UNITED STATES PATENT AND TRADEMARK OFFICE

APPLICATION NO.	FILING DATE	FIRST NAMED INVENTOR	ATTORNEY DOCKET NO.	CONFIRMATION NO.
10/643,447	08/19/2003	Jerome A. Cohen	6842-0001-1	4405

Office Action Summary

PATENT COPY W/ANNOTATIONS

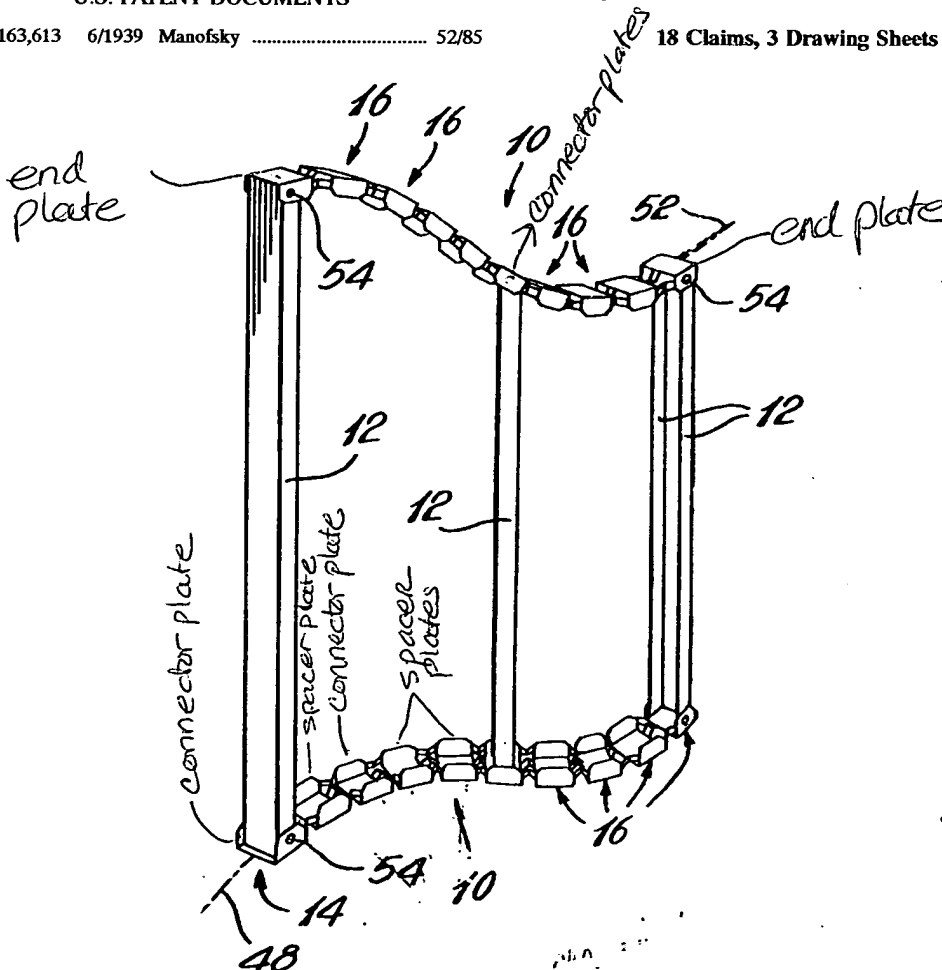
- A plurality of connector plates 16 each including retaining means for receiving an end of a structural member 12;
- A plurality of spacer plates 16; see annotations on patent copy;

The last connector plate on each opposite end has been considered as the end plates. See annotations on patent copy. See 35 USC 112 rejection above. For the other recited elements see 35 USC 102 rejection above.
